Pentium® II Processor Specification Update

Release Date: February 2000

Order Number: 243337-034

ACTUAL vs. EXPECTED RESPONSE

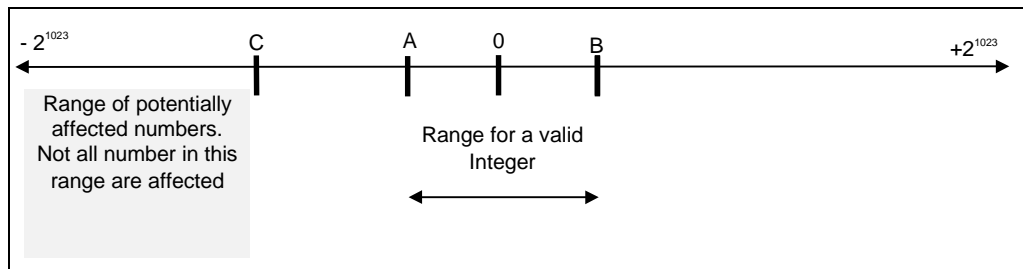
Problem: On certain, large, negative, floating-point operands, and only in three of the four possible processor rounding modes, the instructions FIST[P] m16int and FIST[P] m32int do not detect that the operand is so large that it will not fit into the target data size. As a consequence, the expected Invalid Operation exception response for this situation is not correctly provided, nor is the Invalid Operation flag set in the Floating-Point status word as specified in the *Intel Architecture Software Developer's Manual, Volume 2: Instruction Set Reference*. Under the failing conditions, noted below, the precision exception (#PE) flag will also be incorrectly set.

Implication: Erroneous operation results when the operand is so large that it will not fit into the target data size. The operands affected by this erratum are significantly outside (by a factor of 3X) the range that can be, correctly, converted to an integer value. The figure below and corresponding table identifies the normal range of integer numbers (between A and B) and the starting point of the operands affected by this erratum. Discrete failing operands will be present in the range between point C and the maximum negative number that can be represented by the processor (-2^{1023} in double precision format). Note 2 below gives a qualitative description of the nature of the discrete failing values. Software that does not rely on the Invalid Operation exception flag being set and signaled by either an exception OR by software polling is not impacted by this erratum.

The expected processor response when the invalid operation exception is *masked* is:

- Return the MAXNEG value (8000h for FIST16 & 80000000h for FIST32) to memory.
- The IE (Invalid Operation) bit in the Floating-Point status word is *set* to flag the overflow.
- The PE (precision error) bit in the Floating-Point status word is *not set*.
